To: Auburn Planning Board
 From: Megan Norwood, City Planner II
 Re: 101 Merrow Road, (PID 186-015), Futureguard Holdings, LLC, Special Exception & Site Plan Review Amendment in the Industrial zoning district.
 Date: October 8, 2019

I. PROPOSAL – Mike Gotto, of Stoneybrook Consultants, on behalf of Futureguard Holdings, LLC, is applying for Site Plan Review and Special Exception in accordance with Sec. 60-45 and 60-578(35), expansion of 10,000 square feet or more in an Industrial Zone, for a Phase 3 Expansion of 36,094 square feet to the east side of the existing building. Futureguard manufactures retractables, fixed awnings and screen solutions.

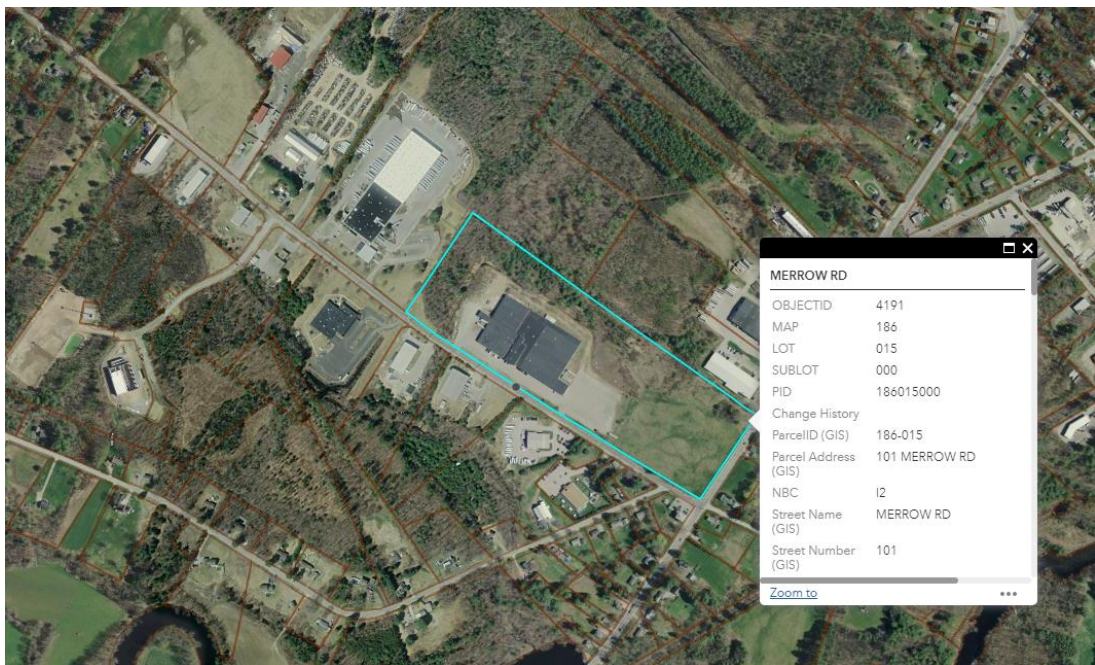
The expansion also proposes changes to traffic flow and parking areas. The April of 2019 approval included 17 additional parking spaces on the West Side of the building. Phase 3 proposes an additional 43 parking spaces along the rear of the building and 12 additional spaces in the rear of the Phase 3 expansion. This brings the total number of parking spaces to 121 with 3 designated as handicapped.

- *Density*. Not more than 40% of the total lot area shall be covered by buildings.
 - The total acreage for the parcel is 27 acres. Therefore, roughly 10.8 acres are allowed for lot coverage by buildings. With this addition, the building footprint is proposed to be 5.3 acres, therefore, meeting this requirement.
- *Setbacks*.
 - Rear: 50 Feet Required. 223 Feet Provided.
 - Side: 35 Feet Required. 338 Feet Provided.
 - Front: 35 Feet. 37 Feet Provided.
- *Landscaping*.
 - Within a parking lot, landscaping shall be provided in an amount equal to 10% of the area of the parking lot. There appear to be five separate areas designated for parking and some

do designate green space. We recommend the Applicant quantify the amount of green space in the parking areas to ensure it meets this requirement.

- The front of the building facing Merrow Road does have a strip of grassed area and green space is designated along the sides of the building and rear. The Square Footage of the building is approximately 231,102 Square Feet based on prior approvals. The 20% requirement would require roughly 43,220 Square Feet of “landscaping.” We also recommend the Applicant quantify the amount of landscaped area around the building to ensure it meets this requirement in lieu of the large addition.

The Planning Board should decide, based on the extent of the expansion, if a landscape plan should be submitted meeting the criteria discussed above: 10% of the parking areas, 20% of the building footprint,

and requirements for side/rear lot lines between nonresidential uses. Is the grassed area in the front of the parcel adequate for meeting the landscaping requirements?
